# CITY OF ALBUQUERQUE

**RE: 2 Alikhani, Naser – Home  
1200 Hideaway Lane SE  
Grading and Drainage Plan  
Engineer's Stamp Date: 06/21/21  
Hydrology File: M23D017A**

Based upon the information provided in your submittal received 06/21/2021, the Grading & Drainage Plan **is not** approved for Building Permit and Grading Permit. The following comments need to be addressed for approval of the above referenced project:

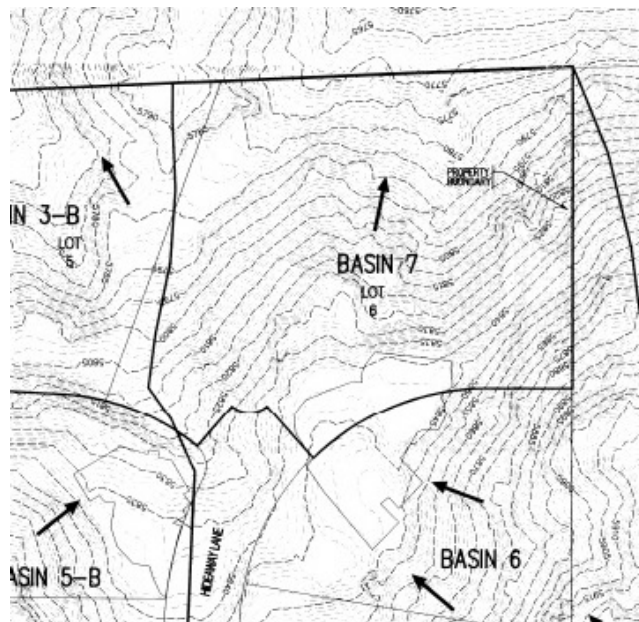
1. This lot is part of the Drainage Report for Four Hills Village 21<sup>st</sup> Installment by Bohannon Huston dated May 22, 2009 (M23D017). This drainage report states that each lot is required to pond developed flow greater than existing flow, so for lot 6 the existing flows is 9.62 cfs and that the lot is to discharge to the northeast as historic flow pattern. (see below).

A problem that I see is that a wall was illegally installed along the northern boundary of the lot sometime in 2010. The City does not have any records of the construction of the lot since a Grading & Drainage Plan would have been required to build it. This wall is currently impeding the historic flow pattern outlined in the approved Drainage Report. A solution will have to be created to resolve this issue.

SHEET 2 OF 2

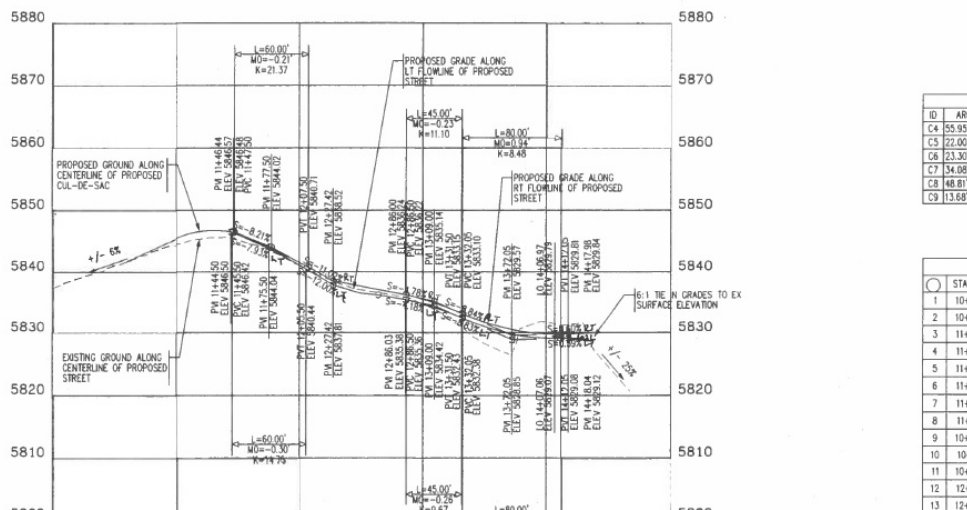
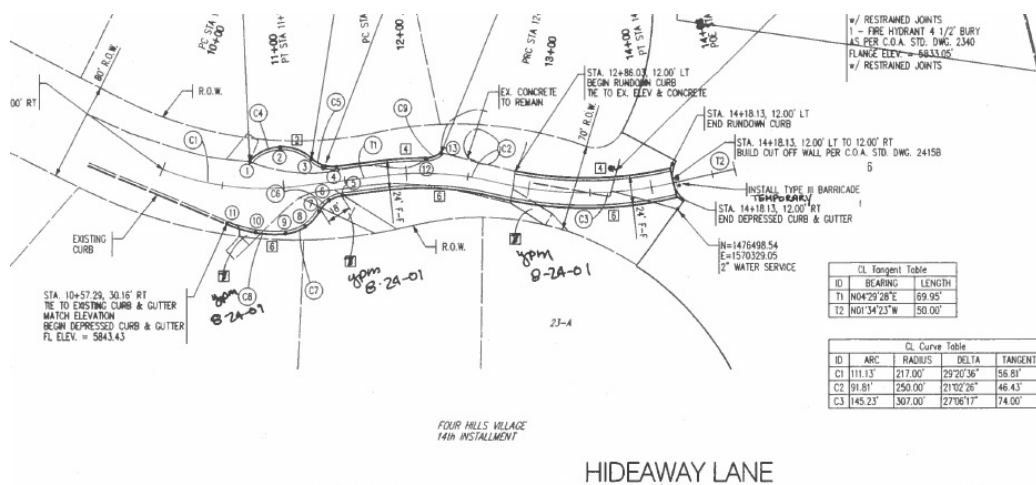
2. Please size a detention pond as outlined in the approved Drainage Report and the existing pond that exists may have to be filled in.
3. According to the recorded plat for this subdivision, each lot Owner is required to provide an individual soils report from a Geotechnical Engineer for review and acceptance by the City of Albuquerque. This is very important since 2009 this lot Owner has been dumping earthwork onto this site so that the material currently there is not native to the site.
